BUILDING INSPECTION REPORT AND DEFECTS LIST

Lot 32 No. 5 Sample Ave, Sampletown North

SCHEDULE OF BUILDING DEFECTS

FIGURE 4.7 DEFAULT MINIMUM CLEARANCES FOR RECESSED LUMINAIRES

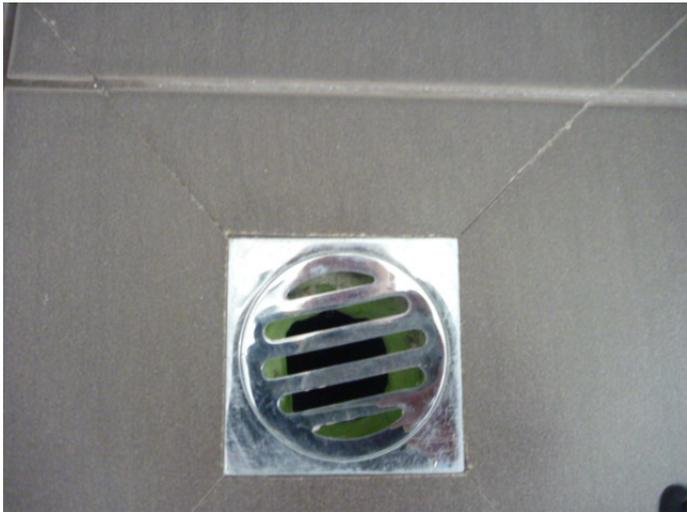
13. Roof Cavity	<p data-bbox="411 1556 1517 1655">The ceiling insulation has not been installed around the light fitting snugly enough and has currently been left up to 400mm away from the sides of the downlights; as well as up to 200mm away from the side walls, which will be significantly reducing its effectiveness.</p>

Australian Standard A.S. 3000:2007 Wiring Rules only require that insulation be kept 200mm away from halogen downlights as per Figure 4.7, shown below-

Sustainability Victoria’s Energy Smart Housing Manual warns that ‘if ends and edges of batts are not snugly fitted then up to 5% of the ceiling area will not be properly covered, which would lose up to 50% of the potential insulation benefit.’

14. In addition to the above there have been no batts installed under the heating platform and walkway, which will also need to be properly rectified.

The present insulation must be rectified so that it is fitted around the light fittings correctly as required by Australian Standard AS/NZs 3000:2007 Wiring Rules to achieve the required R-value and across the entire ceiling area.
